## HISTORIC AND DESIGN REVIEW COMMISSION

**HDRC CASE NO:** 2015-149  
**COMMON NAME:** 600 Block of Burleson at Olive  
**LEGAL DESCRIPTION:** NCB 515 BLK 17 LOT A15 `  
**ZONING:** IDZ H  
**CITY COUNCIL DIST.:** 2  
**DISTRICT:** Dignowity Hill Historic District  
**APPLICANT:** Pam Carpenter  
**OWNER:** K/T TX Holdings, LLC  
**TYPE OF WORK:** Revisions to previously-approved prototype  
**REQUEST:**

The applicant is requesting a Certificate of Appropriateness to approval of Prototype 5 to be included as a house option in the approved development at the 600 Block of Burleson and N Olive.

RE: HDRC 600 Burleson – Certificate of Appropriateness, Final Approval  
Application for Prototype 5 [Resubmit]

5-A3.04

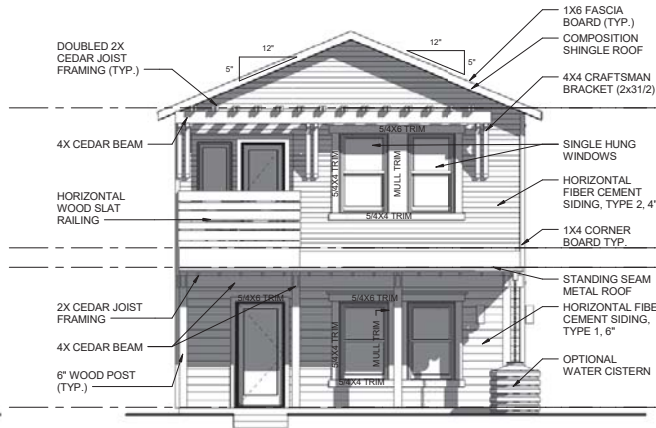
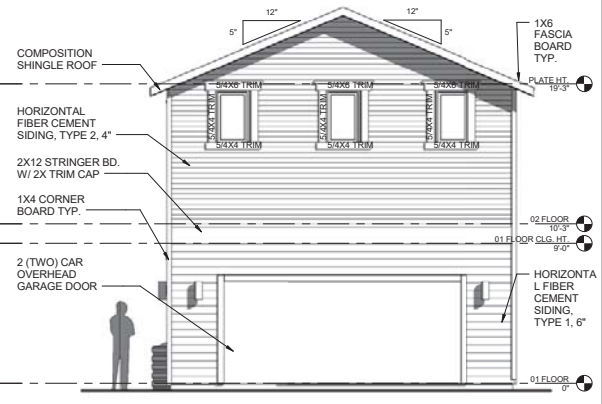
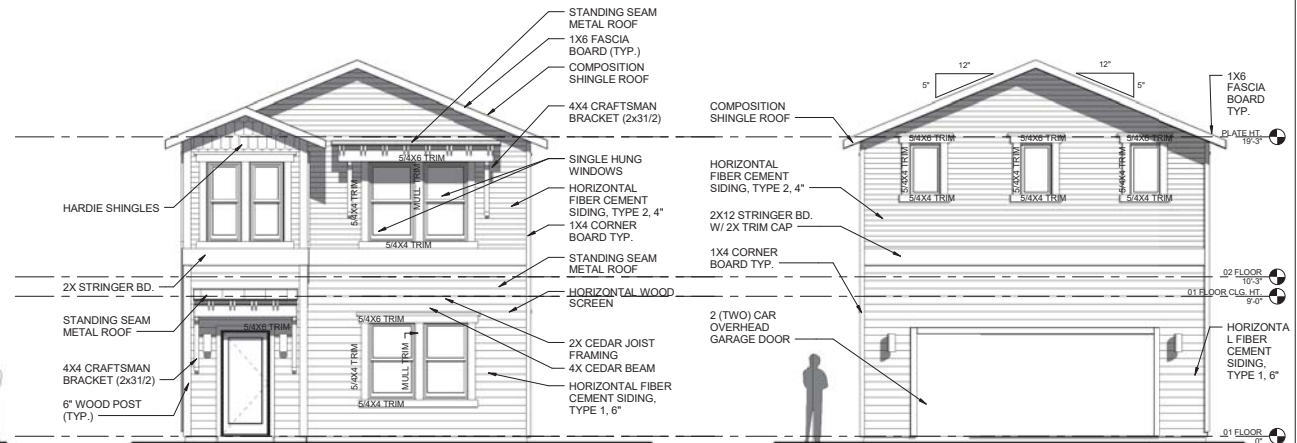
- b) The current proposal eliminates an overhanging porch on the front façade and incorporates a new, front-gabled bump out at the first floor entrance and 2<sup>nd</sup> floor space above. The full-width porch on the front façade has been eliminated.

- d) The Guidelines for New Construction recommend new buildings have roof forms including pitch, overhangs, and orientation that are consistent to those predominantly found on the block. The proposed front gabled roof form is consistent with the Guidelines.

- j) The Guidelines for New Construction recommend that architectural details and building forms follow the established pattern found within the district. In the current prototype proposal, the front porch has been eliminated and replaced with a stoop. A larger front porch, or a porch that has traditional proportions, would be more appropriate. Furthermore, the submitted drawings do not provide sufficient detail regarding the materials and dimensions of the proposed concrete stoop.

1. That the applicant submit a window detail or section that specifies the use of a block frame window that has a minimum recess of 2" based on finding i;
2. That a larger front porch be incorporated instead of a stoop based on finding j. Sufficient detail regarding the design of the porch must be presented to staff.

# SELECTING WINDOWS FOR NEW BUILDINGS

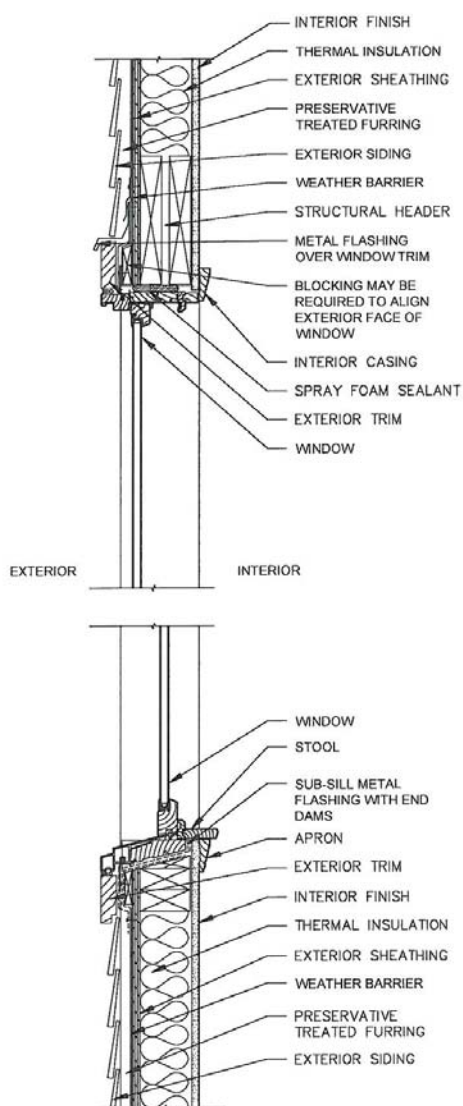
- i) Consistent with the Guidelines for New Construction, windows used in new construction must maintain traditional dimensions and profiles and should be recessed within the window frame. Windows with a nailing strip are not recommended. The corresponding page from the adopted windows policy document has been added to the exhibits for this request. A window detail or wall section which illustrates conformance with the guidelines for window has not been submitted.
